**DESIGN AND HISTORIC REVIEW COMMISSION – MAY 19, 2022
STAFF REPORT**

APPLICATION TYPE:		CASE:	
River Corridor Review		RC22-06: 1028-1040 Holiday Drive	
SYNOPSIS:			
<p>The applicant has applied to the Design and Historic Review Commission (DHRC) for a River Corridor District Overlay Zone approval for four new, two-story townhomes. The townhomes will have a combination of different building materials. The first floor will have EIFS facades with stone around the entryways and painted metal garage doors. The second floor will have a combination of board-and-batten and cedar siding, and the roof will be constructed of composite shingles.</p>			
LOCATION:		LEGAL DESCRIPTION:	
Southwest of S. Bell. St. and South Concho Park Drive		Holiday Terrace Replat, Section 1, Block 2, Lots 1-4	
SM DISTRICT / NEIGHBORHOOD:	ZONING:	FUTURE LAND USE:	SIZE:
SMD District #3 – Harry Thomas Glenmore Neighborhood	RM-1	Downtown	0.25 ac.
THOROUGHFARE PLAN:			
<p>Holiday Drive – Urban Local Street, required: 50’ ROW, 40 paved or 36’ paved with a 4’ sidewalk; provided: 50’ ROW, 40 paved. S. Concho Park Drive – Urban Local Street, required: 50’ ROW, 40 paved or 36’ paved with a 4’ sidewalk; provided: variable

Tower Elevation

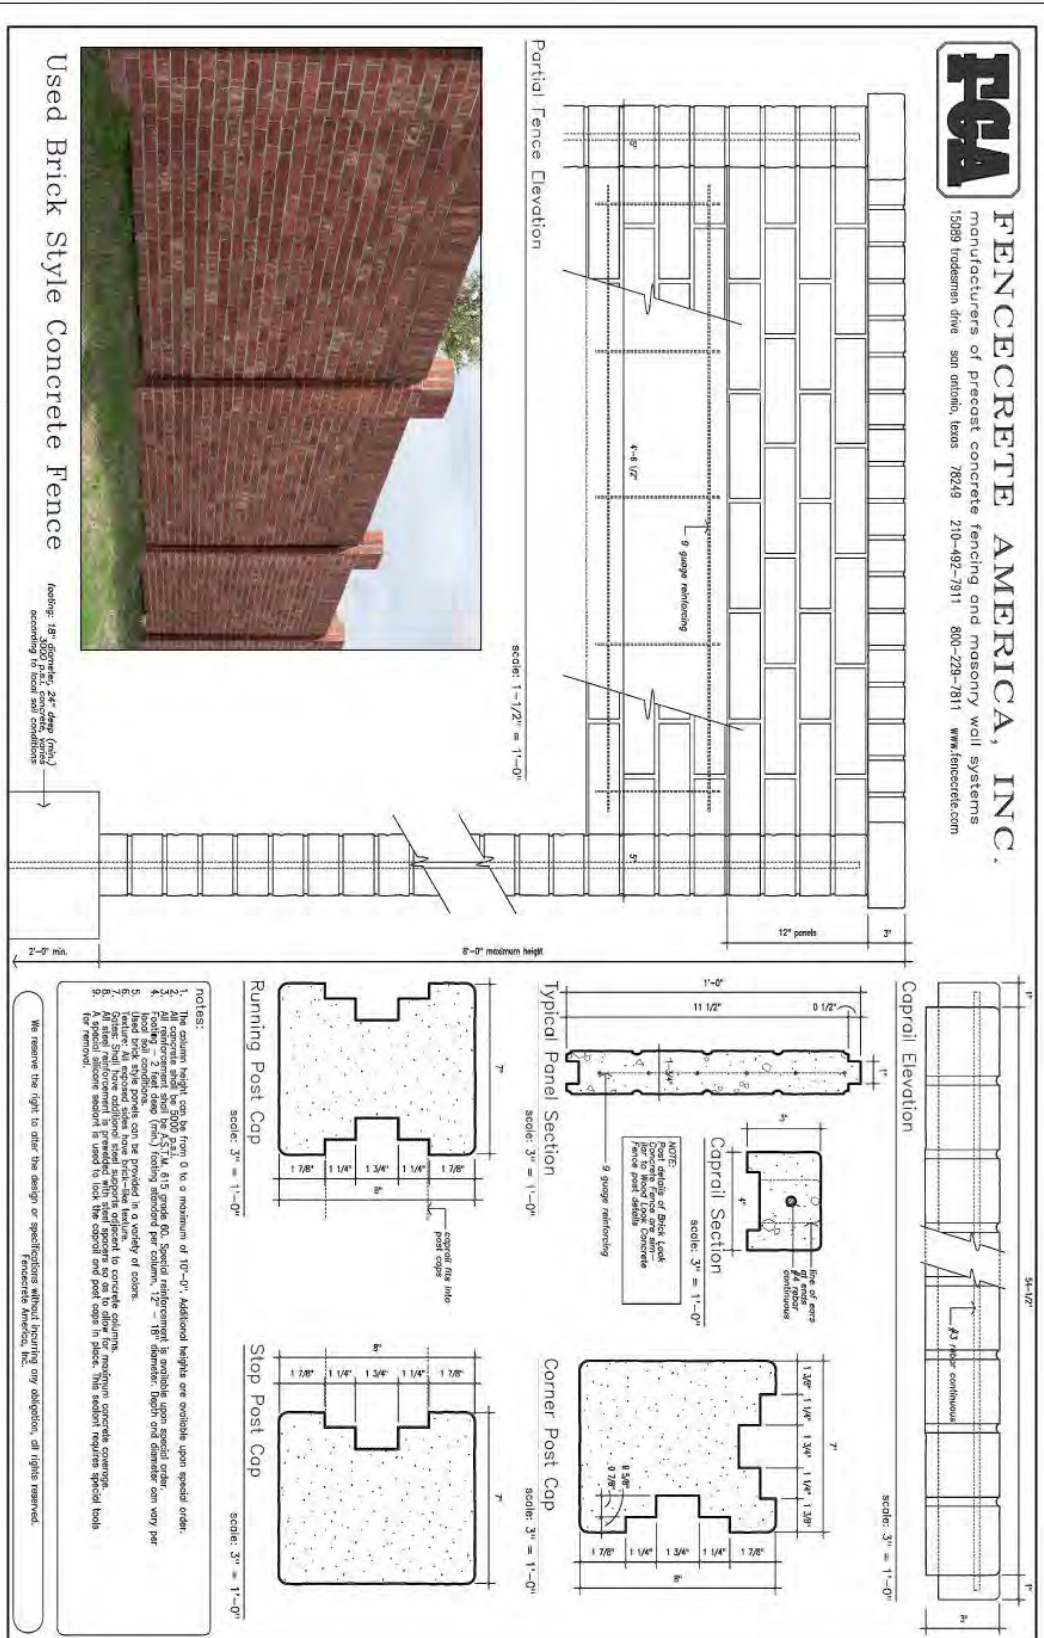
The respective policies state that “development should relate to the site’s setting, considering impacts and enhancements to natural features and important view corridors.” The site is most visible from College Avenue and the applicant has located the new tower and equipment along with screening wall at the far northeast of the property. As indicated, this will be 195’ back from W. College Avenue, reducing impacts and view corridors from the street. The tower will be located immediately adjacent to another parking lot for Shannon Medical and will be at least 172 feet from this property line facing North Oakes Street.

The policies recommend “light to medium colors with low reflectivity are preferred.” Staff is satisfied that the light gray color for the tower is consistent with this policy and of similar color to the building immediately to the east. The policies also state that “materials such as stone, brick, and precast concrete, cast stone and architectural metals can be combined to enrich the appearance of a building and highlight specific architectural features.” Staff believes the solid red brick masonry is appropriate and of quality construction. This red brick can be found on buildings in the immediate area including the First Christian Church building across the street. The columns will be slightly elevated to break up the wall expanse. The solid steel tower is of quality construction and typical of monopole tower design.

Staff’s recommendation is for the Design and Historic Review Commission to **APPROVE** DD21-19, **subject to the following three Conditions of Approval:**

1. The colors, dimensions, and materials of all improvements shall be consistent with the renderings

approved by the Design and Historic Review Commission. Minor deviations may be approved by the Planning and Development Services Director.

2. The applicant shall obtain all required permits from the Building Permits and Inspections Division.
3. The applicant shall submit for and obtain approval a Conditional Use from the Planning Commission for the telecommunication tower and related facilities.

SHEET NO.
 3

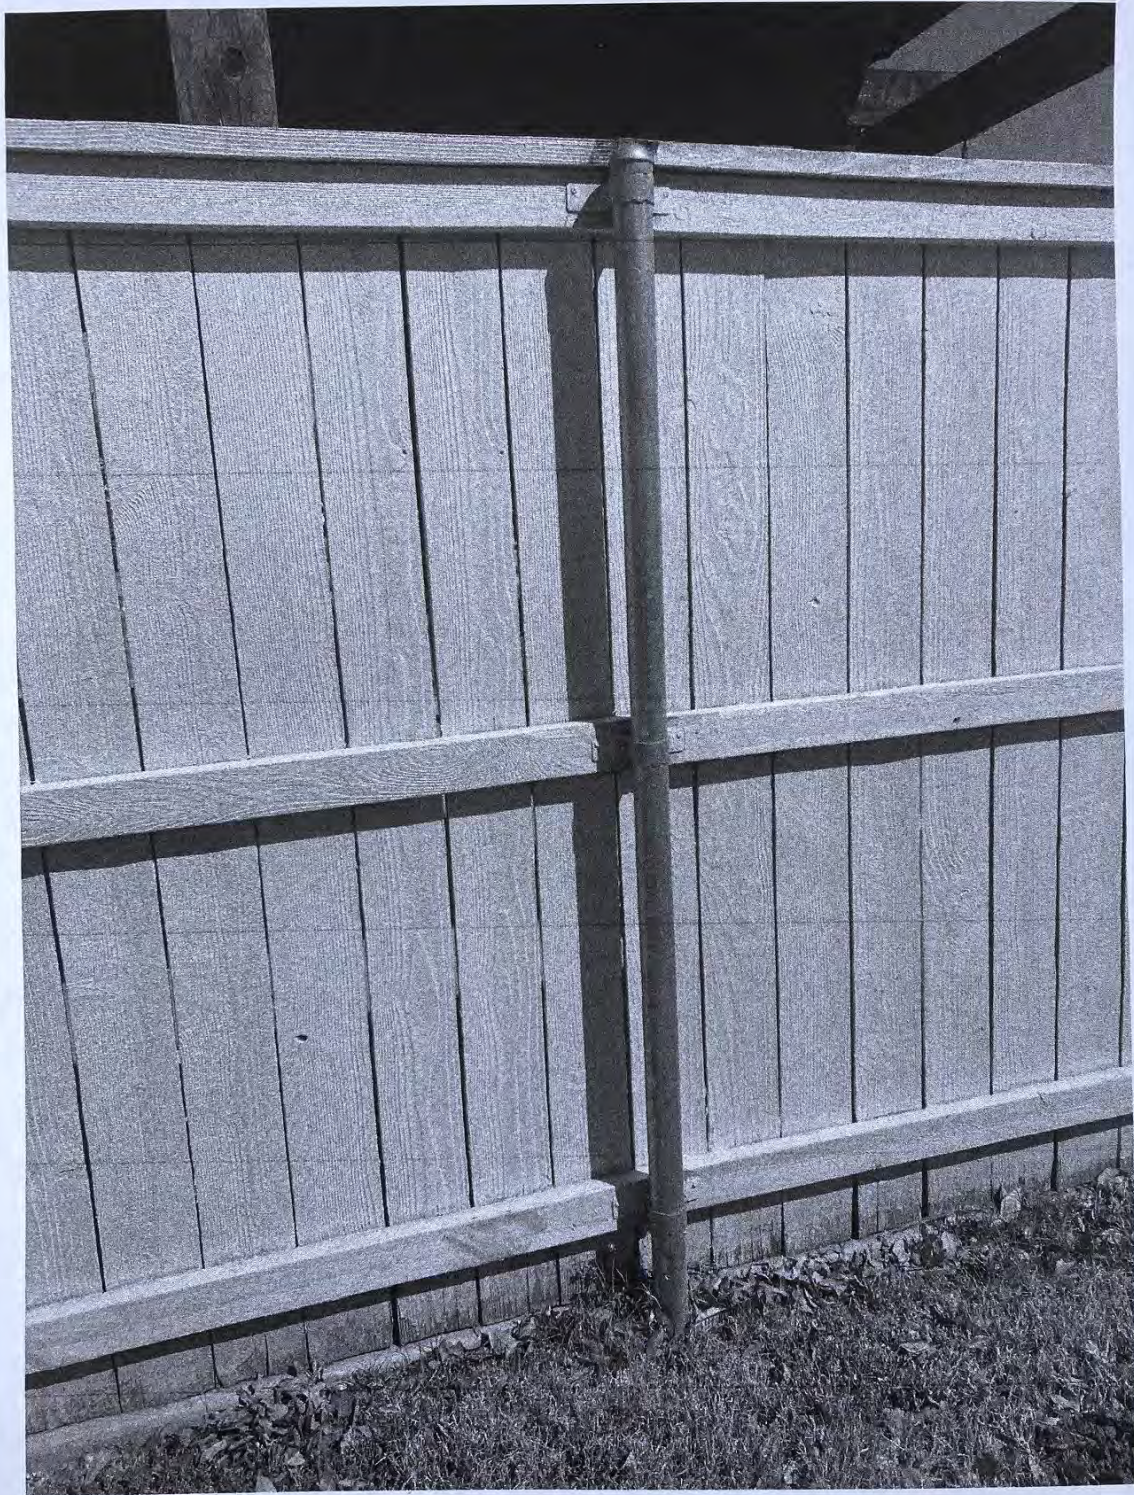
The changes made to the building façade include an added sign to the front face for Zero One Ale House, which will be similar in design for the sign that was approved for their 20 W. Beauregard location (see rendering). The four window awnings will be a Sunbrella Silver color with the third to also have a 6 square foot 'Zero One Z' logo on it. The front stucco color for the building and walk in cooler will have Sherwin Williams 'Knitting Needles' (# 7672) as well as 'Peppercorn' #(7674) for the window trim. (See picture provided for color samples).

The roofline will not be altered in anyway outside of the addition to the walk in cooler addition. The addition will be 9' 6" in height and shorter than the existing roofline.

The proposed fences will be both a tan colored wood picket fence and a black wrought iron fence with gate. The tan colored fence will also have the company's logo (a 50 and 1/3 square foot sign) facing W. First Street. The black wrought iron fence will cover the front of the existing porch cover that extends east from the building with a wrought iron gate to allow for entrance into the covered patio. (See renderings).

Recommendation: Staff's recommendation is for the **approval** of DD22-20: 59 N. Koenigheim to allow repainting and signage onto an existing building, fencing, and walk-in cooler **subject to two conditions of approval:**

1. The colors, dimensions, and materials of all improvements shall be consistent with the renderings approved by the Design and Historic Review Commission. Minor deviations may be approved by the Planning Director.
2. The applicant shall obtain all required permits from the Building Permits and Inspections Division.

New renderings with proposed materials and colors

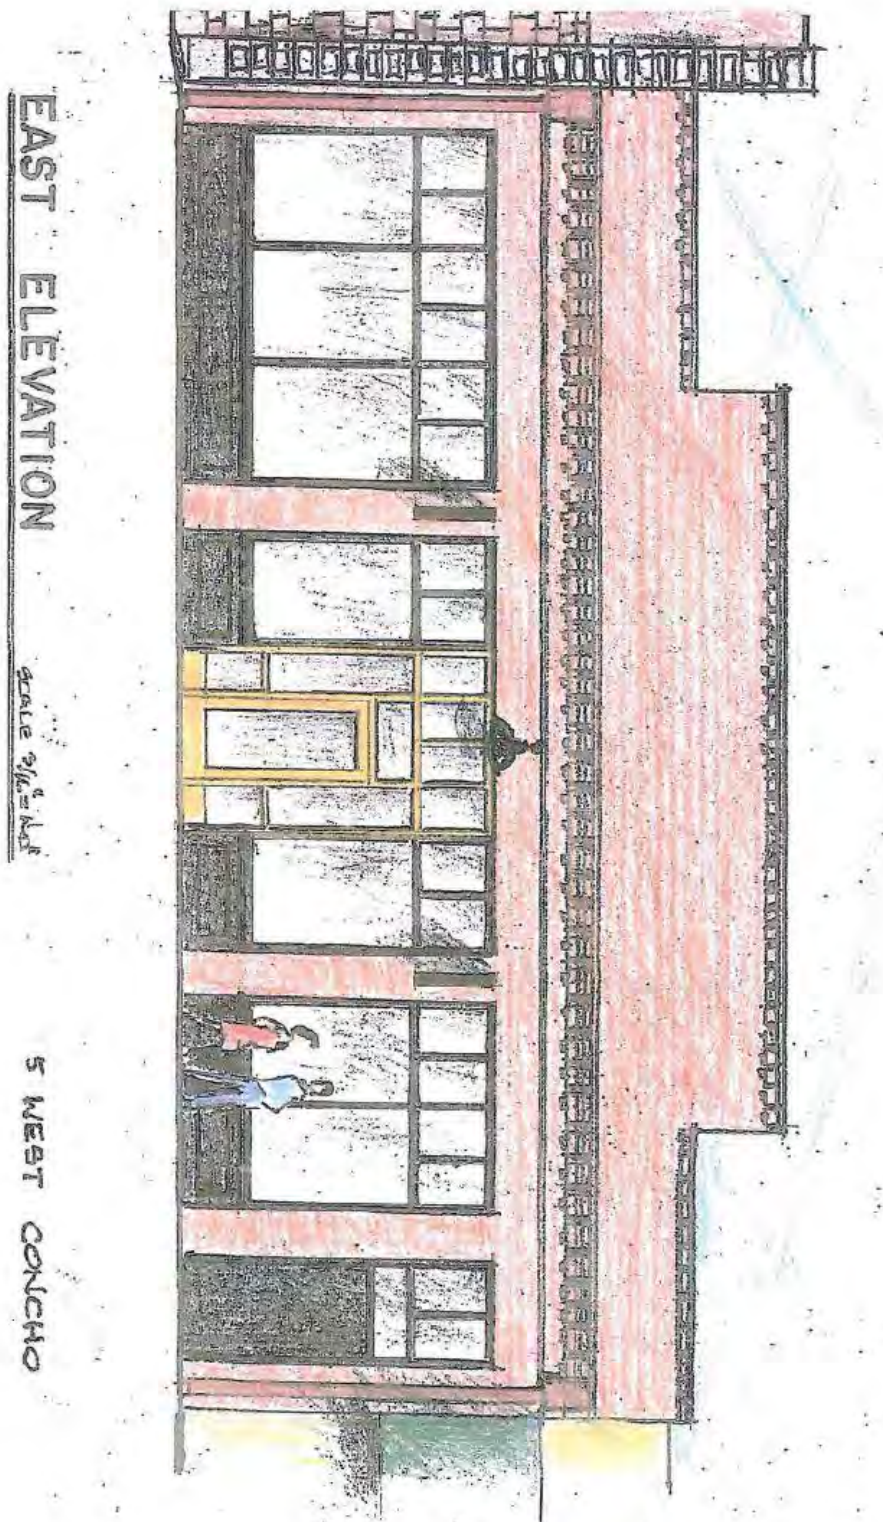
The respective policies state that “patterns and rhythms in the façade of the building can be created with recessed windows, columns, ledges, changes of materials, and other architectural features” and that the basic scale and proportion of windows “should be similar to those seen historically in the area.” The proposed building design is consistent with these policies. The applicant provides differentiation in materials and design, maintain the brick façade but adding cedar panels under the windows, metal downspouts, and new windows and doors. The windows will have a slight horizontal orientation consistent with the adjacent restaurant and other buildings in the surrounding area. They will match the same low insulated glass as the adjacent windows.

The policies state “materials and colors should relate to historic precedents apparent in the immediate environment”. Applicants should use “subtle yet rich colors rather than intense, bright colors” which should be “harmonious with those colors found on adjacent buildings.” Finally, “quality finished materials should be used.” Staff is satisfied with the color and material choices proposed by the applicant which will be generally consistent with the existing Angry Cactus restaurant next door. The red brick façade will be cleaned to match the restaurant, and the wall sconces and downspouts (dark bronze), will be painted to match the adjacent restaurant colors. The classic black color for the paneling will provide an appealing contrast from the lighter colors above and match what was previously approved. Finally, the new doors will be painted to match the existing dark bronze doors on the adjacent building.

Staff’s recommendation is for the Design and Historic Review Commission to **APPROVE** DD22-21, **subject to the following two Conditions of Approval:**

1. The colors, dimensions, and materials of all improvements shall be consistent with the renderings approved by the Design and Historic Review Commission. Minor deviations may be approved by the Planning and Development Services Director.
2. The applicant shall obtain all required permits from the Building Permits and Inspections Division.

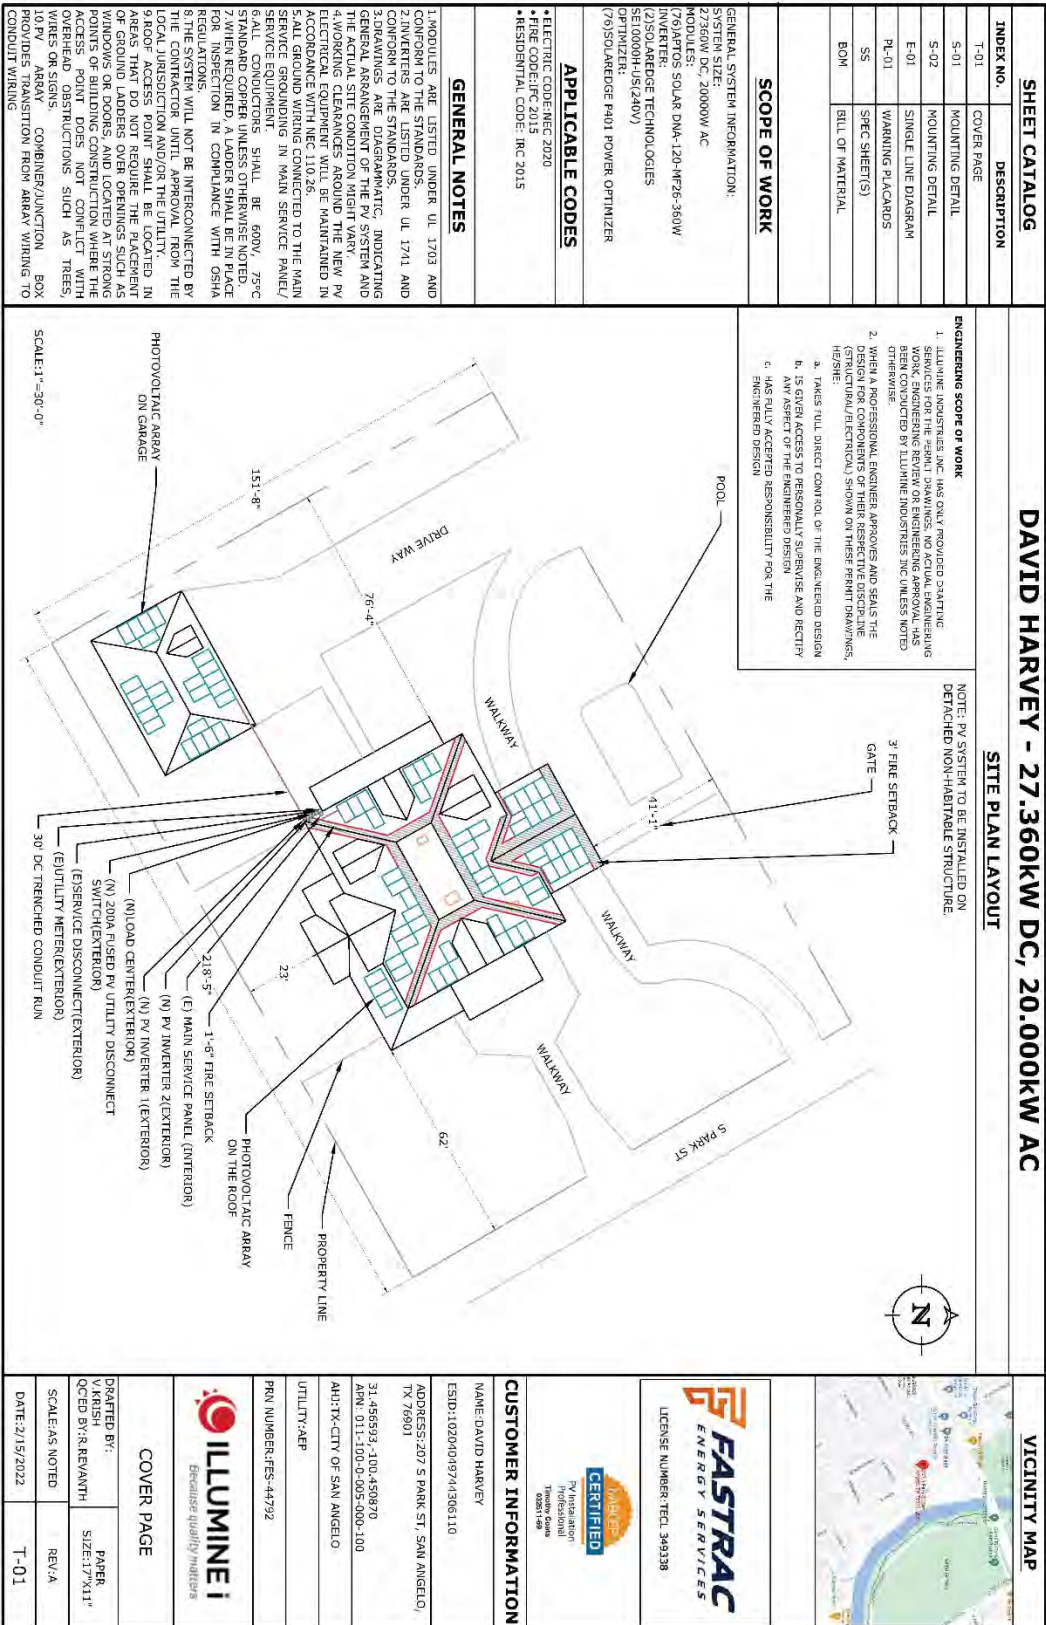
The installation of a roof-mounted solar array that can be seen will drastically alter the historic structure on the property. This project cannot be done in any less intensive manner, other than opting away from a roof-mounted solar array for a ground solar array.

The solar array will drastically alter the historic character of the structure by introducing a non-period specific feature to the roof. There is no way the building can maintain its original quality by the introduction of this roof-mounted array as the roofline will be permanently altered in character and quality.

The proposal to install modern roof-mounted solar panels to this historic home, that can be seen, does not satisfy the requirements found in this review for a Certificate of Appropriateness. There is no intention to modify the solar panels to be fit as period-specific or to deter from a contemporary form whatsoever.

The installation of a roof-mounted solar panel structure will leave repairable damage to the roof of this historic home. The damages will be able to be repaired at the time of removal of the solar panels. The main concern is with the alteration the permanent obstruction to the sight line on the roofline of this historic home for the existing panels that can be seen.

Staff's recommendation is for the Design and Historic Review Commission to partially **approve** the request for a Certificate of Appropriateness for the installation of a roof-mounted solar array at the subject property 207 S. Park St., being 0.688 acres. Following three (3) conditions:

1. That the approved solar panels be mostly if not completely out of sight at street level.
2. That the approved solar panels meet all obligations of the DHRC.
3. That the owner obtain all appropriate building permits for the solar panels.
